ITEM 6 | LANDSCAPE MASTER PLAN

DRV18-00312 Appeal
Enclosure 2, Attachment 2
Page 25 of 64

| MERIT HOMES | CONTINENTAL DIVIDE | DRC PRESENTATION | 1.6.2020 25

ITEM 8 | BLANK WALLS

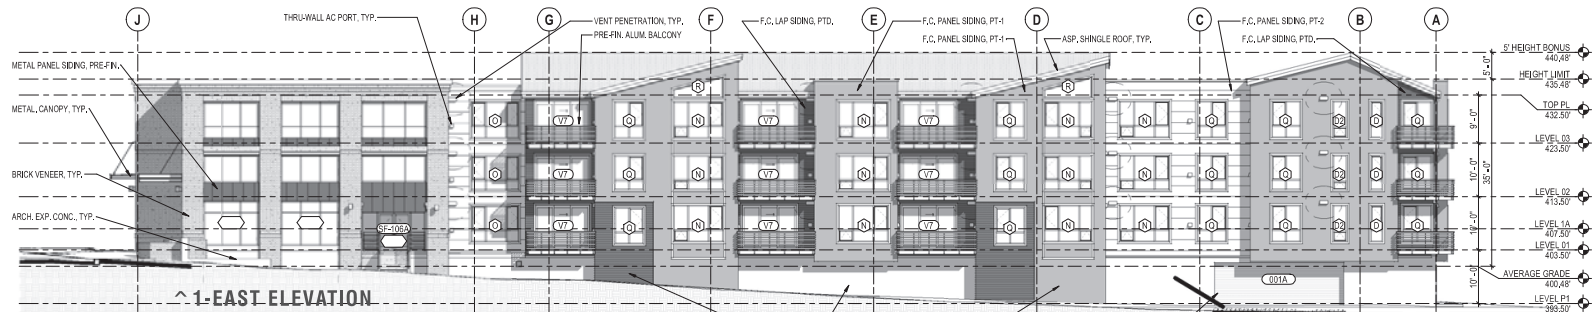
8. COMMERCIAL FACADE DEVELOPMENT

- Additional development of the standalone commercial facade to create a superior design to offset the modification request. Ideas include material changes on the parapets and cornice treatments. We recommend looking at the Hectors Building on Lake Street and the Park Lane Public House for some ideas.
 - a. Also address any blank walls on the backside of the building (See Design Guideline Section 8)

NE 85th St. Pedestrian Experience:

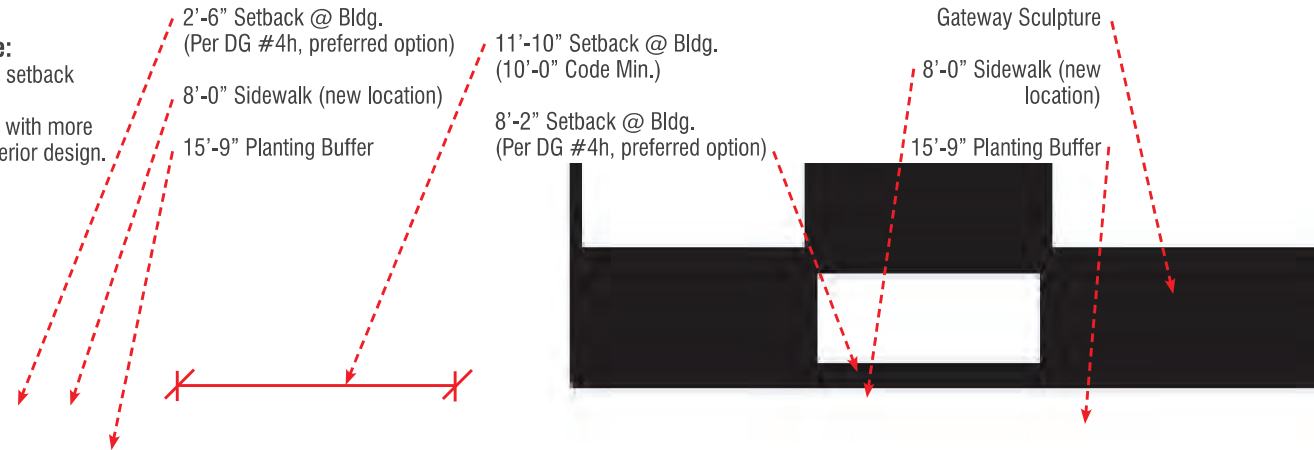
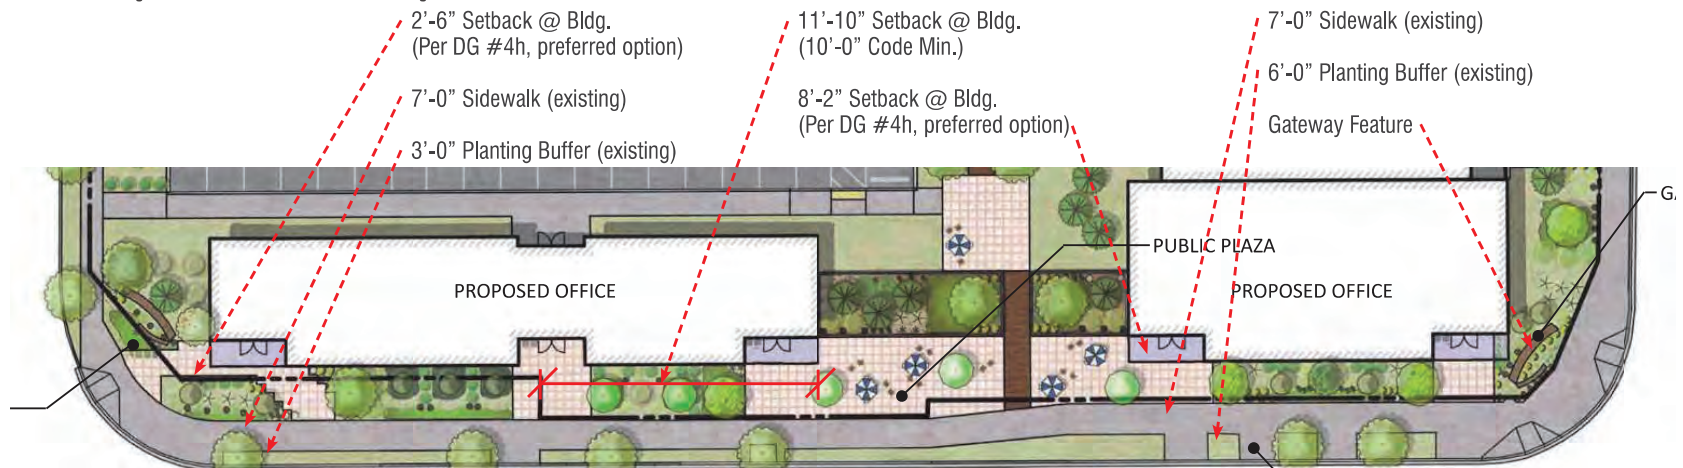
DRC REVIEW | FROM 8/6/18

DG #5a, 5b, 5h

- Meets all requirements for requested setback departure.
- Creates more welcoming streetfront, with more separation from vehicle traffic & superior design.
